SUBJECT: TECHNICAL SPECIFICATION AMENDMENT REGARDING HEATUP AND COOLDOWN LIMITATIONS, JOSEPH M. FARLEY NUCLEAR PLANT, UNIT 1 (TAC NO. 60075)

Amendment No. 71 License No. NPF-2

ATTACHMENT TO LICENSE AMENDMENT NO. 71

SAFETY EVALUATION BY THE OFFICE OF NUCLEAR REACTOR REGULATION

FIGURE 3.4-2 FARLEY UNIT 1 REACTOR COOLANT SYSTEM HEATUP LIMITATIONS APPLICABLE FOR THE FIRST 16 EFPY

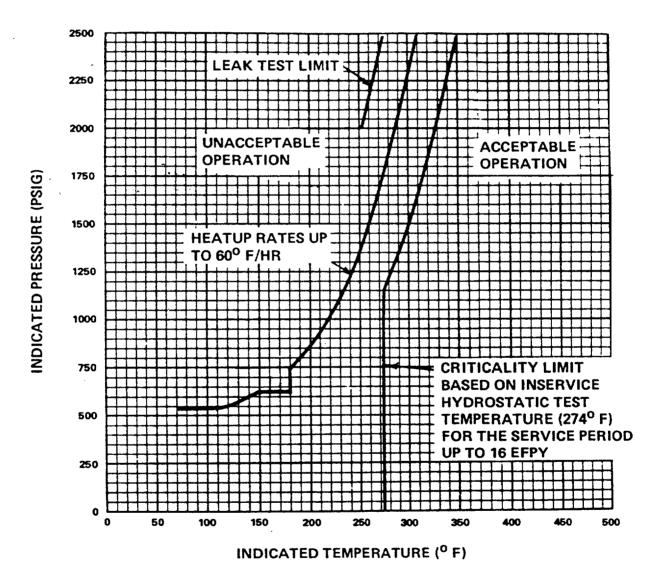
The amendment revises Technical Specification Figures 3.4-2 and 3.4-3, heatup and cooldown limitations based on results of analysis of Capsule "U" Reactor Vessel Material Radiation Surveillance Program. Analysis results are included in the Westinghouse Report, WCAP-10934, Revision 2.

In a letter from R. P. McDonald to S. A. Varga dated October 25, 1985, the Alabama Power Company (the licensee) requested changes to the Joseph M. Farley Nuclear Plant, Unit 1 (Farley-1) Heatup/Cooldown Curves and supporting bases. The staff reviewed the licensee's submittal and determined that the effect of neutron irradiation on all beltline materials had not been assessed by the licensee. The staff's concerns are documented in a letter from E. A. Reeves to R. P. McDonald dated June 16, 1986. In response to this letter, the licensee provided a revised set of heatup and cooldown curves, which were to be applicable for 16 effective full power years (EFPY). The revised curves and their bases were submitted in a letter from R. P. McDonald to L. S. Rubenstein dated September 29, 1986. The curves and bases are to be contained in Figures 3.4-2 and 3.4-3 and Bases Section 3/4.4.10 of the Farley-1 Technical Specifications.

CONTROLLING MATERIAL	:	LOWER SHELL (PLATE NO. B6919-2)
COPPER CONTENT	:	0.14 WT%
NICKEL CONTENT	:	0.56 WT%
INITIAL RTNDT	:	5 ⁰ F
RT _{NDT} AFTER 16 EFPY	:	1/4T, 146.4 ⁰ F
	:	3/4T, 121,5 ⁰ F

CURVES APPLICABLE FOR HEATUP RATES UP TO 60° F/HR FOR THE SERVICE PERIOD UP TO 16 EFPY

FIGURE 3.4-2 FARLEY UNIT 1 REACTOR COOLANT SYSTEM HEATUP LIMITATIONS APPLICABLE FOR THE FIRST 16 EFPY

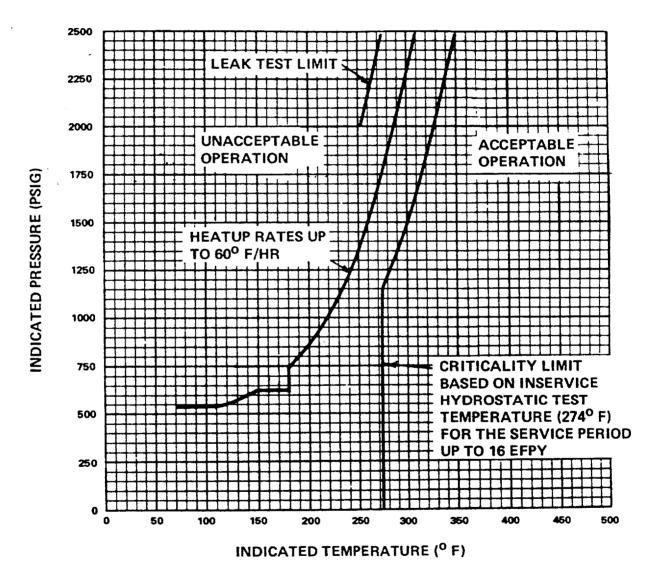
The amendment revises Technical Specification Figures 3.4-2 and 3.4-3, heatup and cooldown limitations based on results of analysis of Capsule "U" Reactor Vessel Material Radiation Surveillance Program. Analysis results are included in the Westinghouse Report, WCAP-10934, Revision 2.

In a letter from R. P. McDonald to S. A. Varga dated October 25, 1985, the Alabama Power Company (the licensee) requested changes to the Joseph M. Farley Nuclear Plant, Unit 1 (Farley-1) Heatup/Cooldown Curves and supporting bases. The staff reviewed the licensee's submittal and determined that the effect of neutron irradiation on all beltline materials had not been assessed by the licensee. The staff's concerns are documented in a letter from E. A. Reeves to R. P. McDonald dated June 16, 1986. In response to this letter, the licensee provided a revised set of heatup and cooldown curves, which were to be applicable for 16 effective full power years (EFPY). The revised curves and their bases were submitted in a letter from R. P. McDonald to L. S. Rubenstein dated September 29, 1986. The curves and bases are to be contained in Figures 3.4-2 and 3.4-3 and Bases Section 3/4.4.10 of the Farley-1 Technical Specifications.

CONTROLLING MATERIAL	:	LOWER SHELL (PLATE NO. B6919-2)
COPPER CONTENT	:	0.14 WT%
NICKEL CONTENT	:	0.56 WT%
INITIAL RTNDT	:	5 ⁰ F
RT _{NDT} AFTER 16 EFPY	:	1/4T, 146.4 ⁰ F

CURVES APPLICABLE FOR HEATUP RATES UP TO 60° F/HR FOR THE SERVICE PERIOD UP TO 16 EFPY
